CONSTRUCTION PLANS for TABLE ROCK HOMESTEADS

AS-BUILT RECORD SET

COVER SHEET

TABLE ROCK HOMESTEADS
C1.2
SHEET 2 OF 5

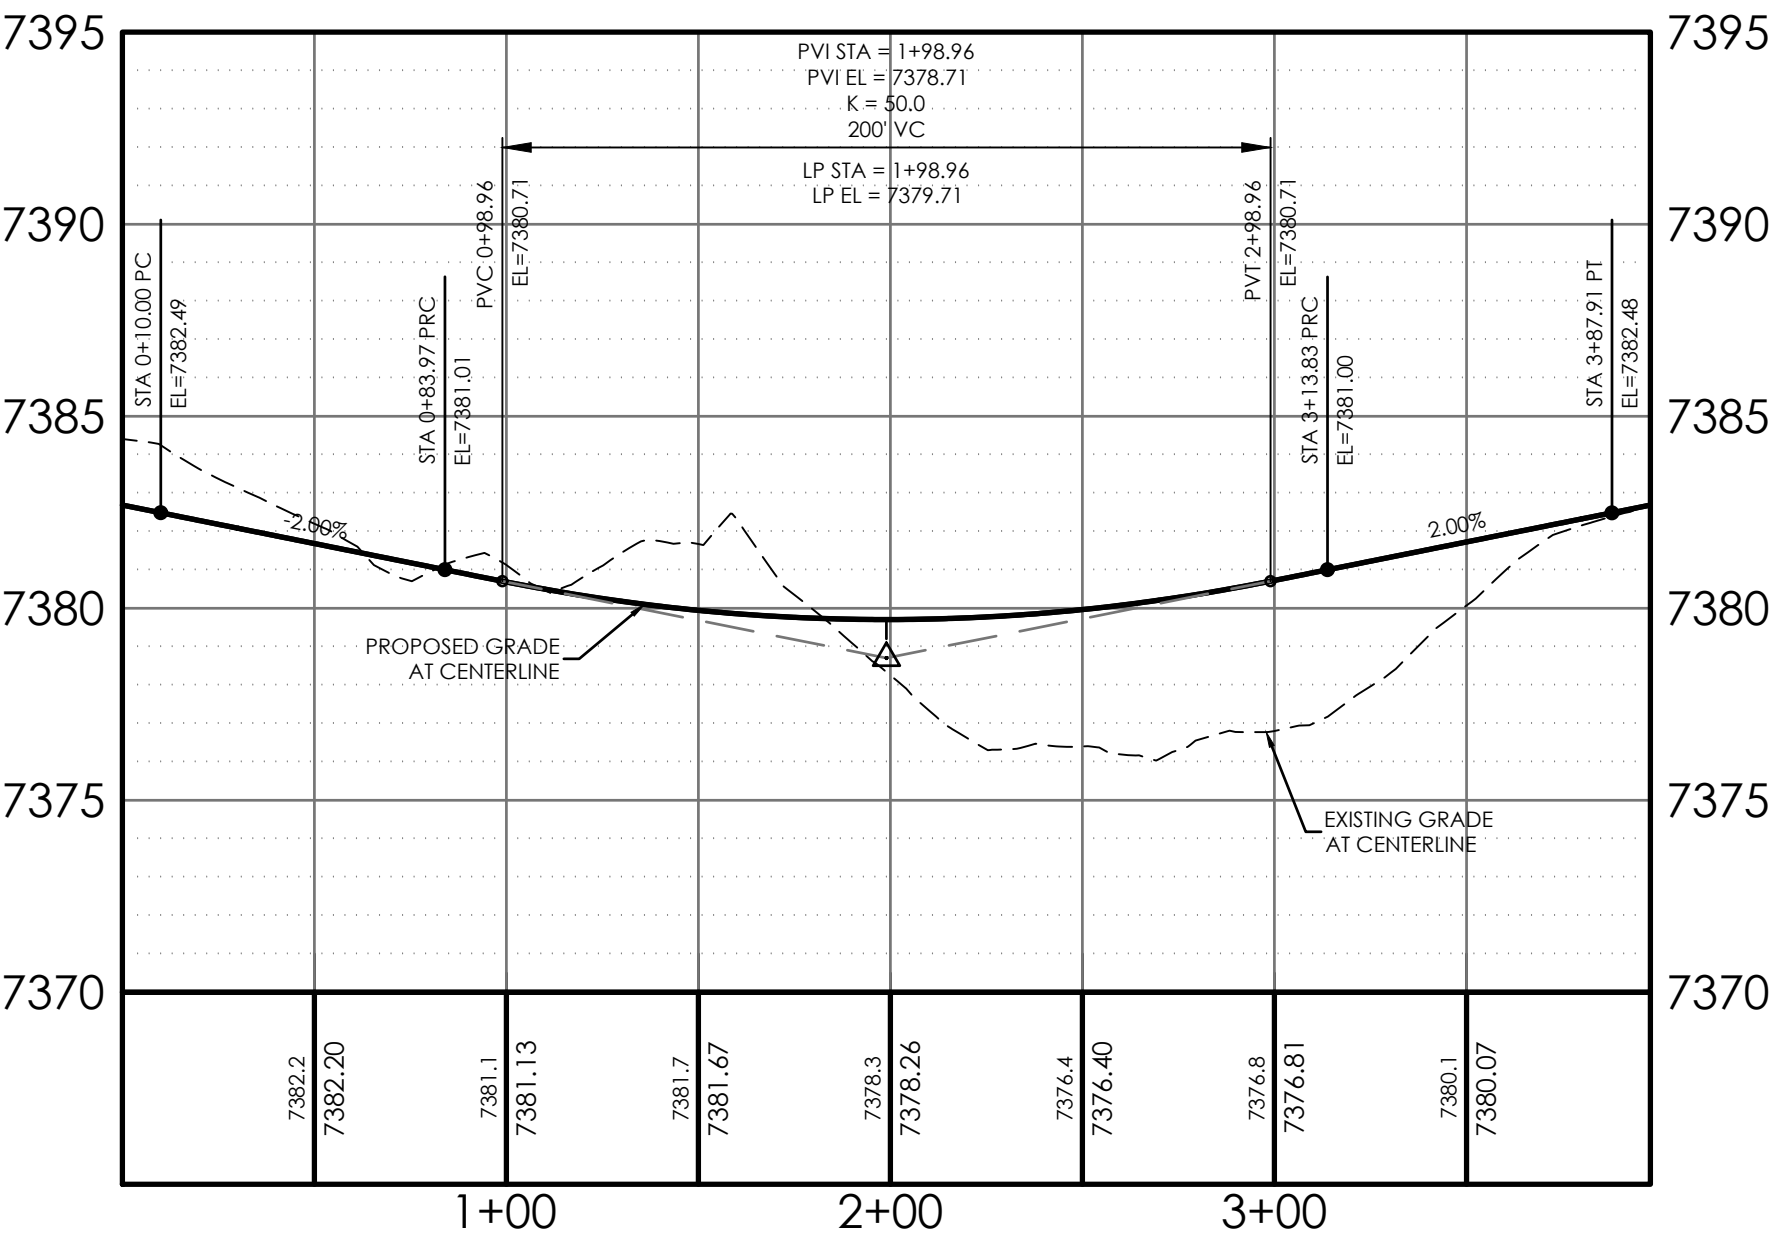
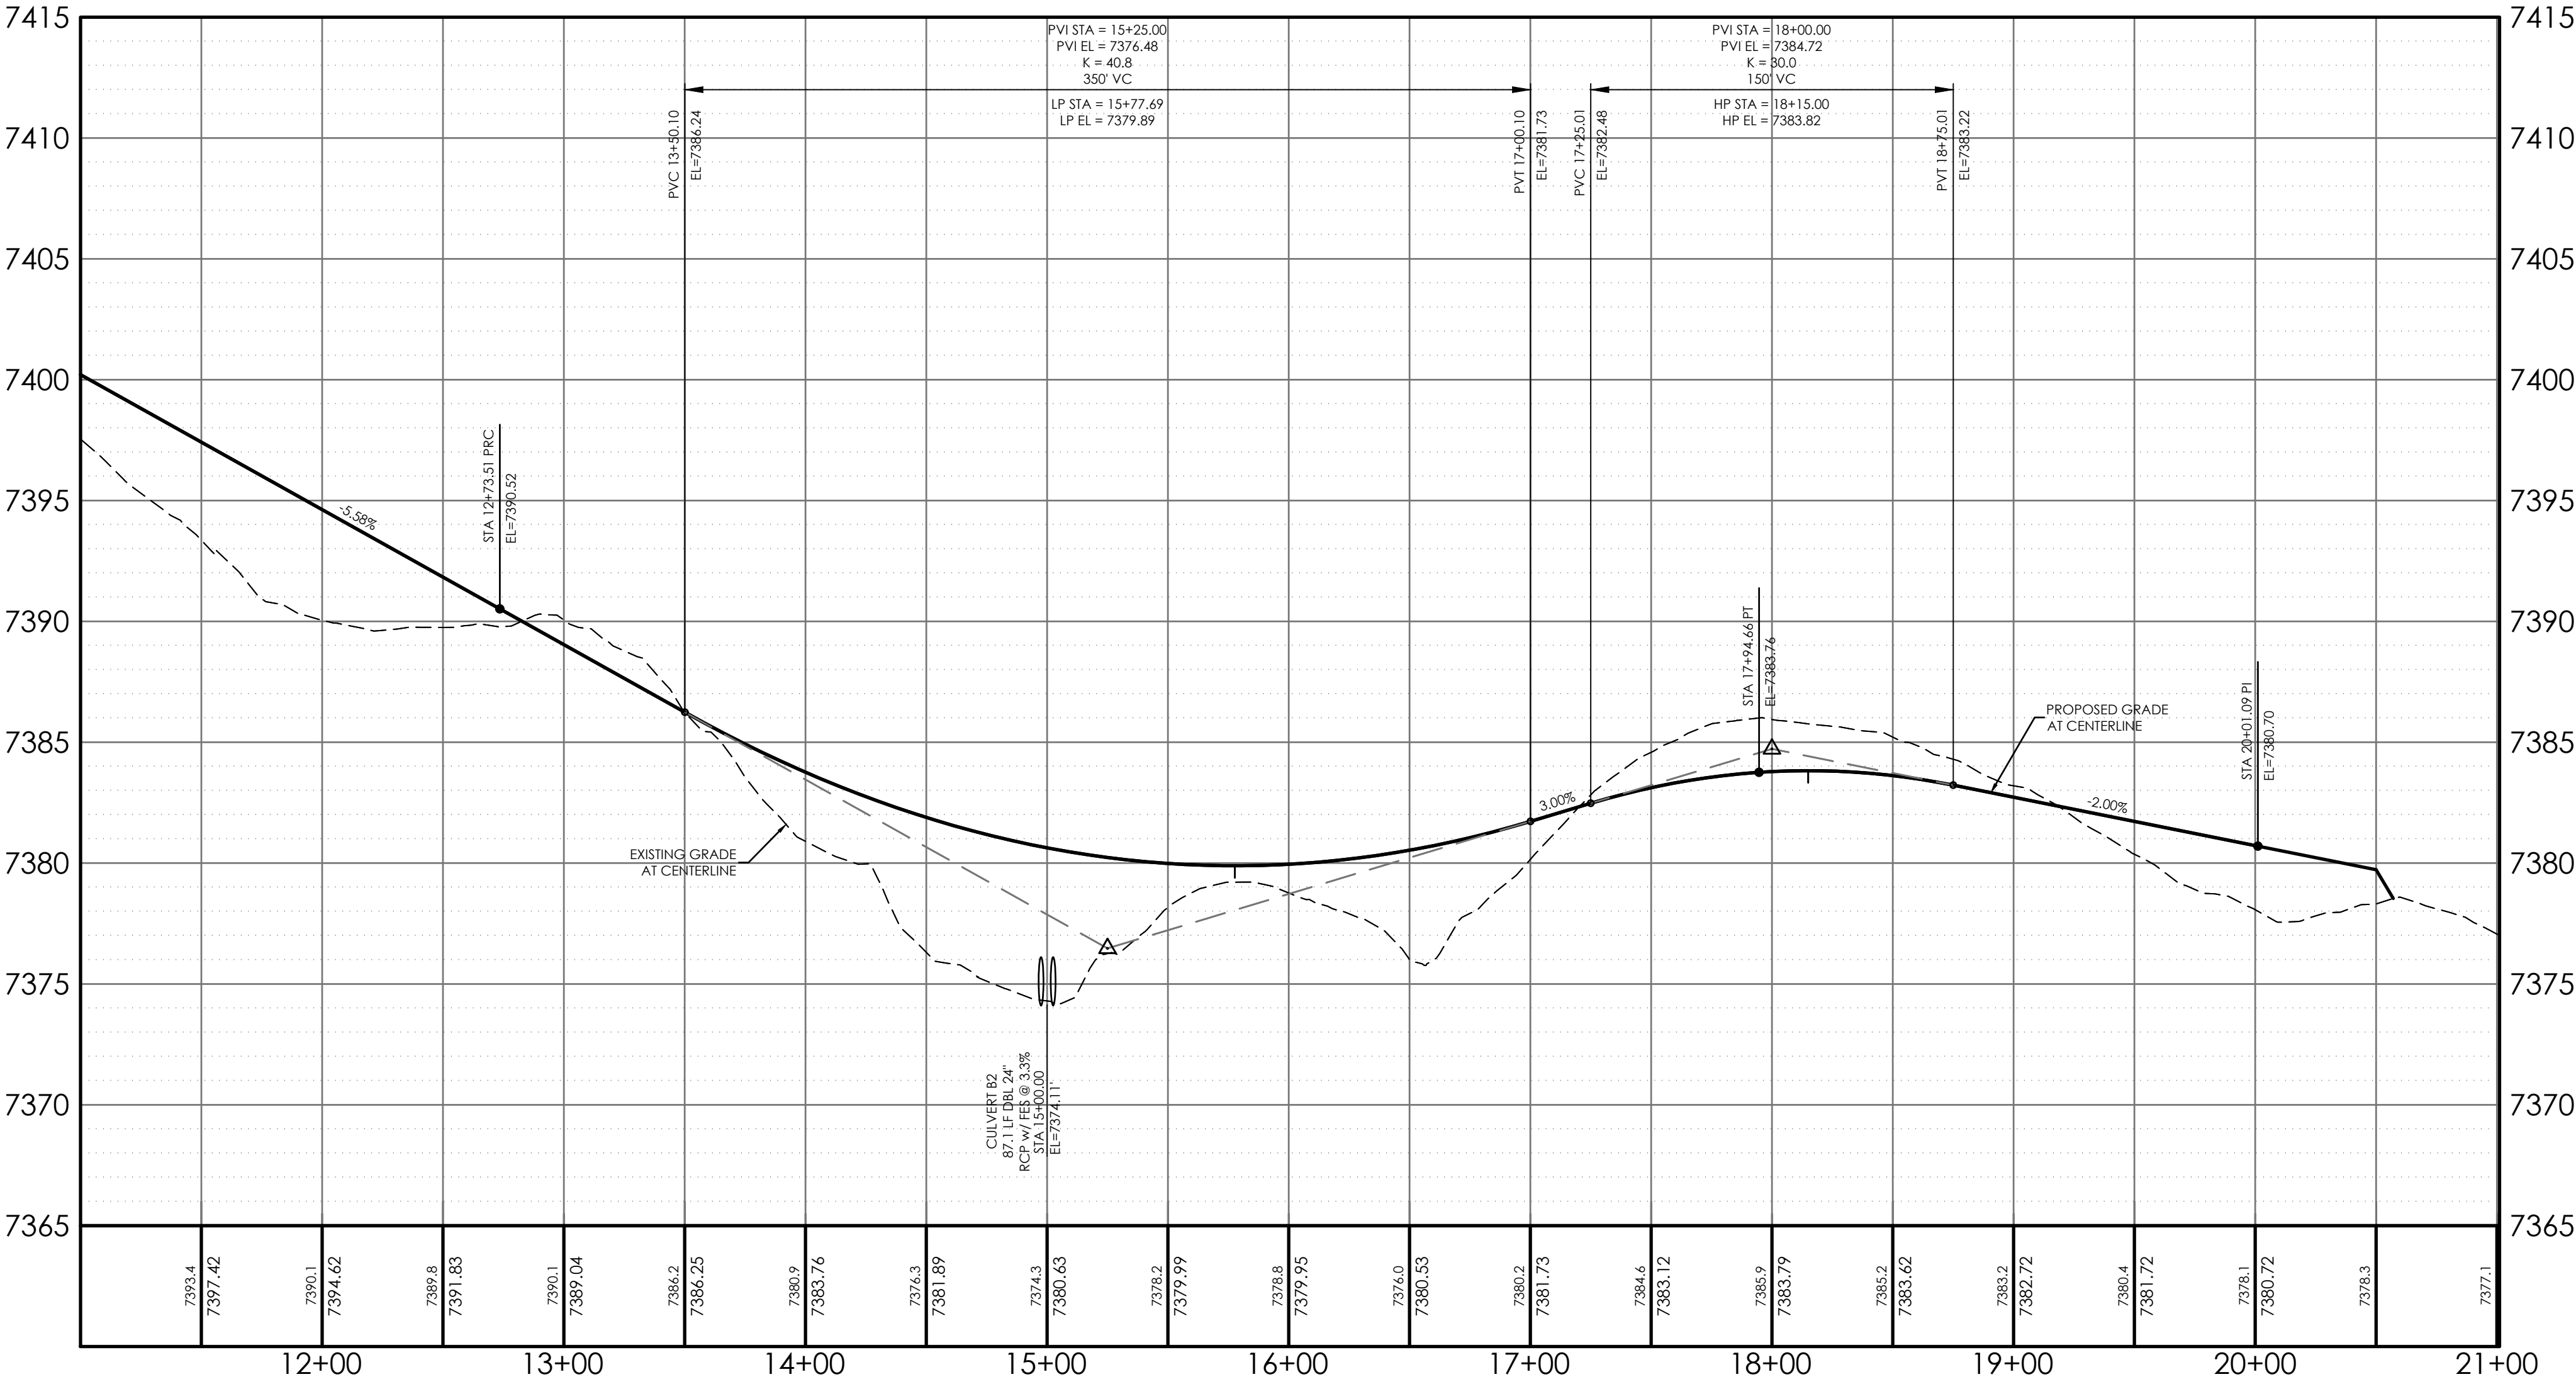
Stormwater PA Punchlist finding:

All other permanent rock check dams are about 2' W when plans call for 8' W. Install per approved plans or consult the Engineer of Record (see Note 1) Reference Photos #5-8.

MVE: please discuss this with the developer to see if/how they resolved this in the field. Basically the check dams shown on the GEC Plans as interim/final were all too short in the direction parallel to flow in the swales, so they did not match what is required on the typical detail on Sht 5 of the GEC Plan. Let me know via email or phone call what you find out. If it was supposedly addressed already in the field, I'll have our inspector go verify it so that we can cross that item off of the punchlist and know that nothing needs to be redlined on these as-builts. Thanks.

Additionally: consider need for a sheet like Sht 2 of the GEC Plan to as-built the permanent check dams.
